**HIMACHAL PRADESH
PUBLIC WORKS DEPARTMENT**

No.PWC-WA-I/Forest / Rajera (Bhaniya) Bailly/2020-21-2574-77 Dated 17/06/2020
To

Diversion of 2.62 Hectare of forest land in favour of HPPWD for the construction of link road from Rajera (Bhaiya) to Bailly Km 0/0 to 4/500 within the jurisdiction of Chamba Forest Division Distt Chamba H.P.

Reference: - Nodal Officer, -cum-APCCF(FCA) Shimla office letter No. Ft-48-3914/2009(FCA) dated 11/06/2020.

KM 0/0 TO 4/500 C.S.H.T. - X SEC OF MUCK DUMPING SITE AT VARIOUS RDS

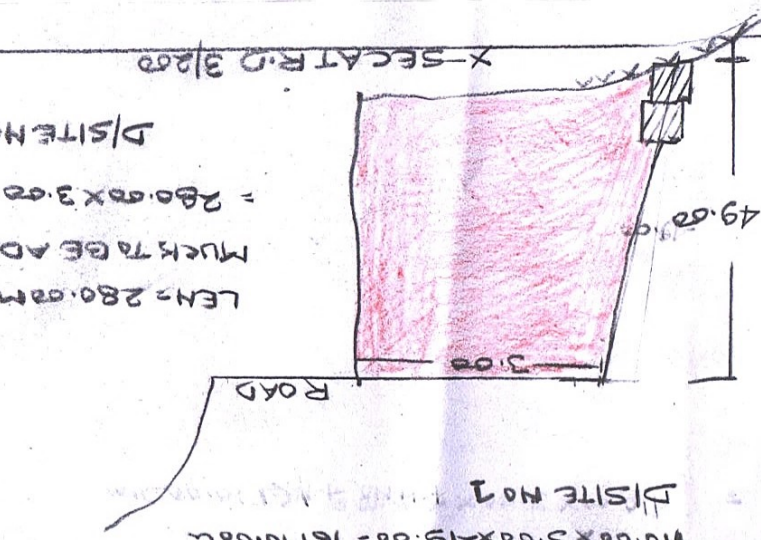
Point No-1. The proforma-V is corrected and same has been uploaded in the online Part-I as additional documents. The total quantity of muck/ debris to be dumped comes out to be 73500 cum instead of 731500 cum as pointed out under your referred letter as above. Similarly the calculation as per proforma-V comes out to be 73500 cum instead of 6405 as pointed out by Gov.t of India.

X-SEC AT R.D 1/900
LEN 110.00 MTR
MUCK TO BE ADJUSTED
110.00 X 3.00 X 49.00 = 16170.00 Cum
D/SITE NO II

LEN = 280.00 MTR
MUCK TO BE ADJUSTED
280.00 X 3.00 X 49.00 = 41160.00 Cum
D/SITE NO III

X-SEC AT R.D 0/100
LEN = 110.00 MTR
MUCK TO BE ADJUSTED
110.00 X 3.00 X 49.00 = 16170.00 Cum
D/SITE NO I
